RE: Review of File # Z25-456PPLT – DRAFT LETTER

This letter is to inform you that the application materials for the above-mentioned Preliminary Plat were found to be technically incomplete, based on a review required under Spokane Municipal Code (SMC) 17G.061.120, Determination of a Complete Application. The following comments were received from various departments and agencies.

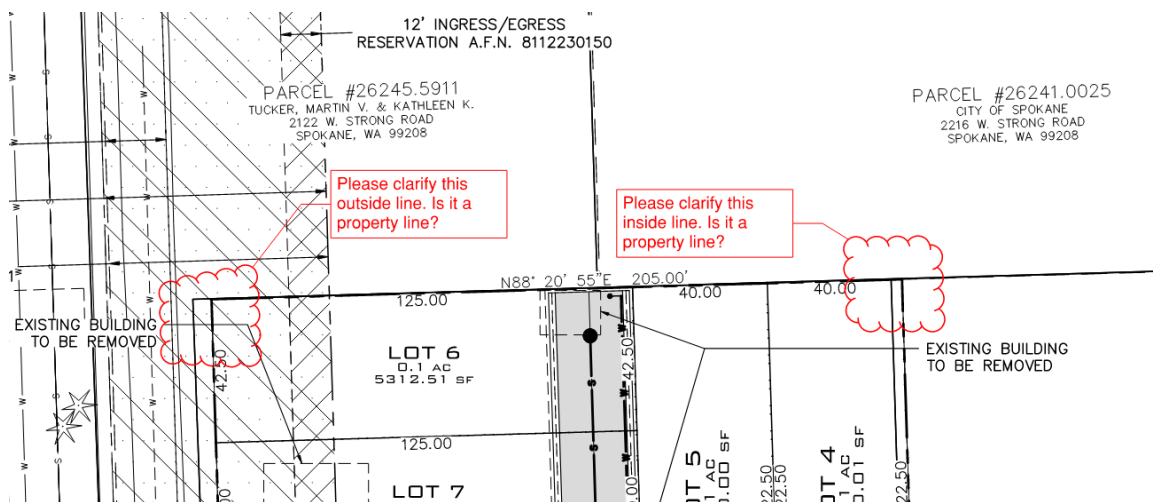
13. There are some unlabeled lines shown on the face of the plat. See snip below. Please clarify.
